SERVICE BULLETIN

No. 464A

Piper Aircraft Corporation

Subject: Inspection of Stabilator Torque Tube Bearing Block Attachment Fitting Rivets.

VIEW A-A: CORRECT RIVET ALIGNMENT

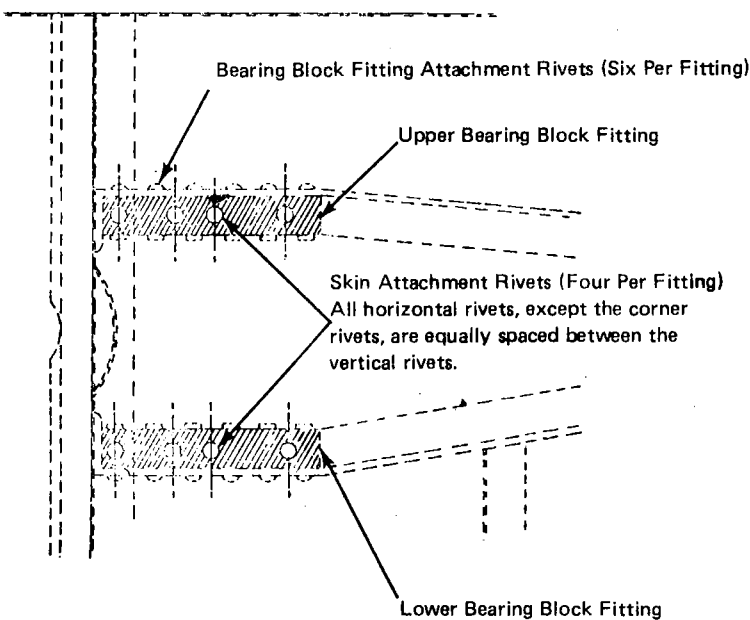
Stabilator Bearing Block Attachment Fitting Rivets (see sketch for an illustration of this condition).

In some instances rivet alignment may be detected during the inspection referred to in Instructions, below, and on the attached sketch/instructions sheet. However, closer inspection may reveal that, although rivet alignment may exist, rivet penetration may not have occurred--in which case, no further action is required.

VIEW A-A: RIVET ALIGNMENT which may have resulted in rivet penetration:

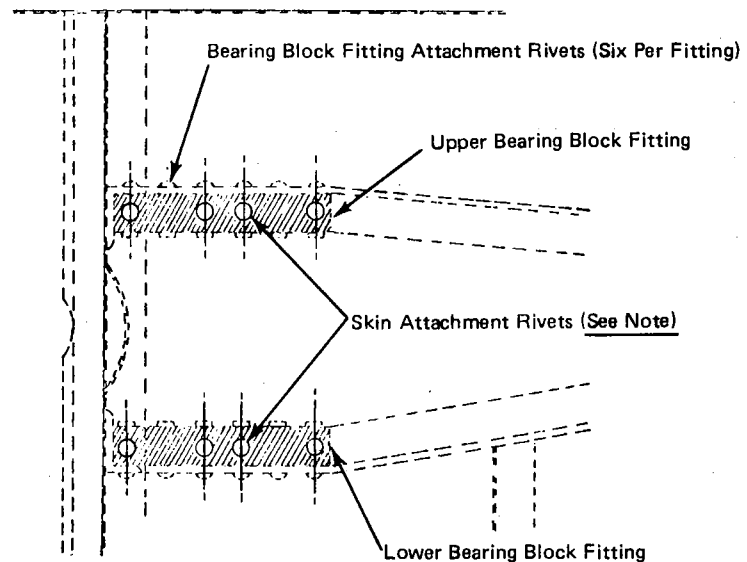
NOTE: All horizontal rivets, except the corner rivets, are incorrectly installed in this view as they are aligned with the vertical rivets. If more than two rivet alignments are evident in each fitting, it will be necessary to install Kit 760 835.

1. Remove the rear fuselage access panel located on the right side of the aircraft just forward of the stabilator.
2. Using a light and mirror (with extension), view through this access opening to determine if any of the horizontally positioned rivets through the skin align with any of the vertically positioned rivets in the bearing block (refer to attached sketch).
3. If more than two (including the corner rivet) rivet alignments/penetrations in any bearing block fitting have been ascertained, installation of Kit Number 760 835 is required in the affected bearing block fitting. Two rivet alignments/penetrations or less as described in paragraph 2, Purpose, above, requires no further action except for the appropriate log book entry.

1. One (1) each PER FITTING (i.e., each kit contains sufficient material to modify one only Stabilator Torque Tube Bearing Block Fitting), Piper Kit Number 760 835, Hi Shear Rivet Replacement, if required per Instructions number 3, above.
2. Two (2) each per aircraft Cover Plate, Part Number 28216-02, if installation of Kit 760 835 is required per Instructions number 3, above.
